#### ENGINEERING EVALUATION / FACT SHEET

Application No.: R14-0024B Plant ID No.: 061-00134

Applicant: Longview Power, LLC

UTMs: Easting: 589.2 km Northing: 4,395.7 km Zone: 17
Description: Applicant request to expand the area from which allowances may

Figure 1. Longview Power Mitigation Plan - Reduced Western Offset Allowance Area

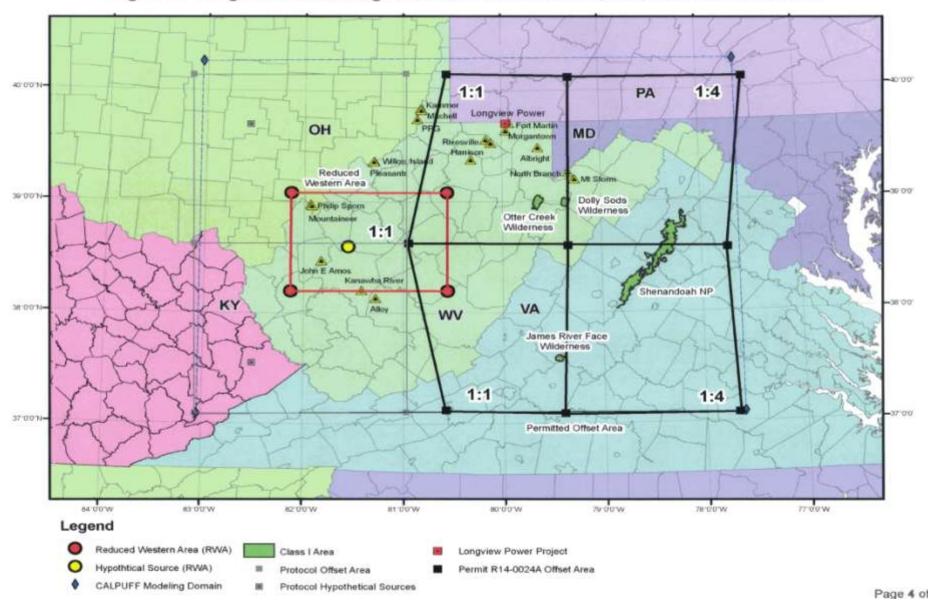
Longview does not contain these two areas but rather identifies a single hypothetical source within a Reduced Western Area, which slightly overlaps the currently permitted Northwest Quadrant and Southwest Quadrant. Since the computed sulfur dioxide offset ratio is the same (1 to 1) for the Reduced Western Area and both the Northwest and Southwest Quadrants, the small overlap has no effect on any required quantity of allowance purchases.

As indicated earlier, the modeling domain, for both CALMET and CALPUFF, was increased to allow for inclusion of the proposed offset area. The modeling domain and proposed offset area are not identical – the modeling domain is necessarily larger than the proposed offset area to allow for adequate functioning of the model (i.e. contain meteorological data and allow for puff recirculation). Boundaries for a modeling domain are generally established based on guidance in the Federal IWAQM Phase 2 Report which recommends extending the domain 50 km beyond the outer receptors and emission sources. Figure 1 shows the Permit R14-0024A offset areas, Reduced Western Area, hypothetical source for the Reduced Western Area, CALPUFF modeling domain, and the offset areas and hypothetical source locations proposed in the protocol.
